**REF: Appeal of Coastal Development Permit CDP04-11; Conditional Use Permit CUP04-21; Site Development Permit SDP04-31; and Environmental Impact Report for South Shores Church Master Plan Project located at 32712 Crown Valley Parkway, City of Dana Point, SCH No. 2009041129**

**Subject: Responses to Appeal of Master Plan Project for South Shores Church Expansion**

Figure P - 20 Feet From Property Line- View from Nearest Residences Toward Parking Garage Ramp Wall

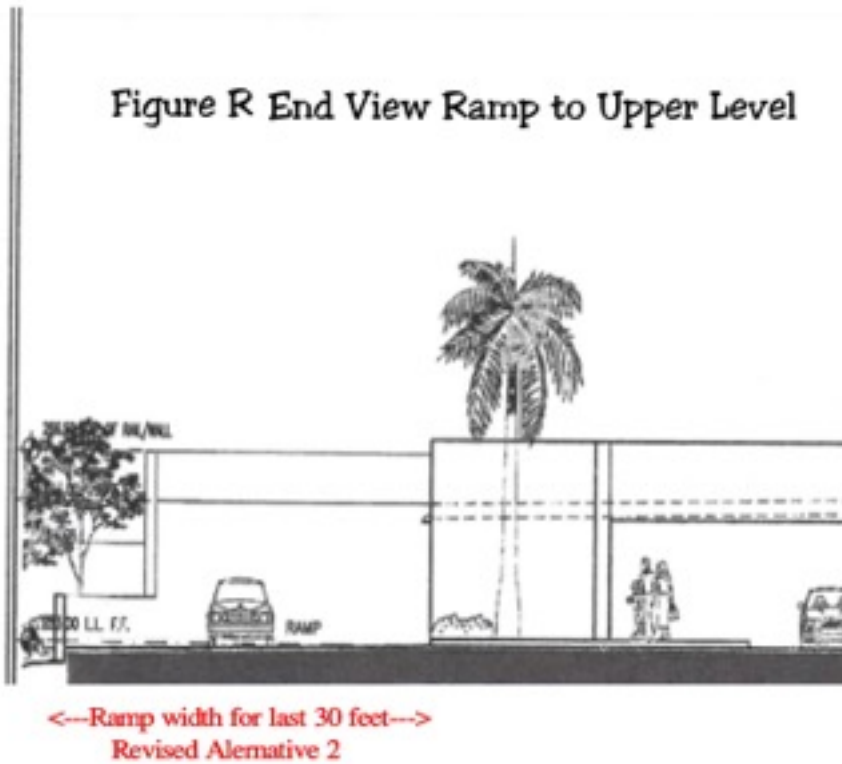
South Parking Structure and Ramp location is still only 20 feet from homes. The lower 30 feet of the Garage Ramp and wall did not move north in the Revised Alternative 2, as stated by Applicant. See Figure R and P below. There are many areas in which the large concrete Parking Structure and Ramp will impact our lives, Noise, Air Quality, Light pollution and Thermal Heating, only 20 feet from our home. The impact of these were not separately analyzed in EIR by LSA. Specifics are identified in Documentation section below.

The portion of Ramp not moved **remains** 20 feet from property lines and at 30 feet from bedroom, for first 30 feet of Ramp length.

See Figure P- 20 Feet From Property Line- View from Nearest Residences Toward Parking Garage Ramp Wall

Location of lower portion of Ramp has an approximately 8 foot wall behind it which will reflect sound back into residences bedrooms. From engine noise, and tires turning to enter and exit Ramp. Additionally any tire to Ramp noise will be amplified by the same structure wall.

Figure P1-Requested Reduced Parking Garage Footprint-Moved North 15 Feet

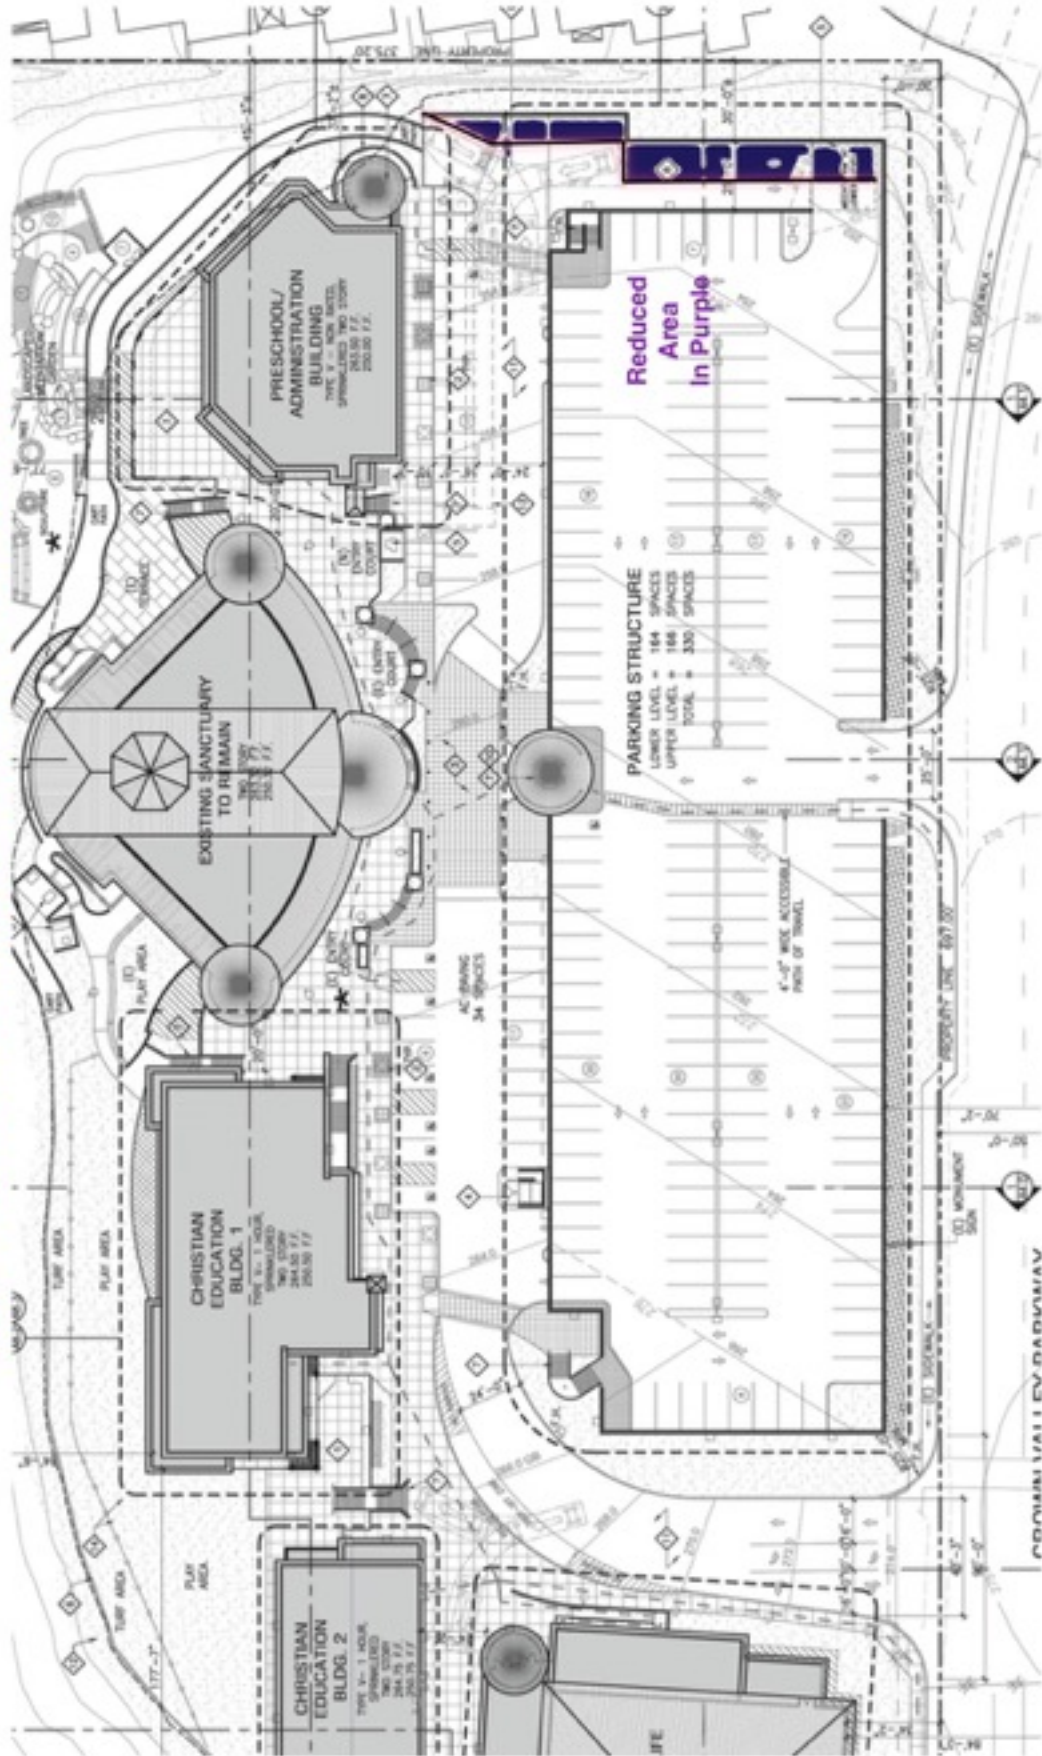
**3. Reduce size of Parking Structure 4-5% and move it 15 feet further north from nearest homes.** By eliminating only 16 spaces in the structure out of 364 spaces, parking structure can be reduced in size by 15 feet. There are 12 extra spaces identified at 10 years, so only 4 required spaces would be eliminated (As defined in the Parking study). See Figure P1 below

If the Parking Demand projection at 10 years can be reduced by only 4 spaces, the South Parking Structure and Ramp could to be moved north approximately 15 "additional" feet from the current Revised Alternative 2 plan.

A solution would be for the Applicant to accept a very slight downward estimation variance (of 4 spaces) on the future Parking needs at 10 years, in addition to eliminating the 12 Surplus spaces currently identified in the parking Summaries. This would allow the South Parking Structure to be reduced in size the width of two spaces. If the applicant removed the 16 spaces, the Parking Garage could be reduced by closer to 18 feet, as each space is sized at 9 feet wide.

Reducing the size would allow the South Parking Structure to move North 15 feet. This solution would almost double the distance from the residences to the south and many existing issues would be mitigated.

See Figure P1- Requested Reduced Parking Garage Footprint-Moved North 15 Feet
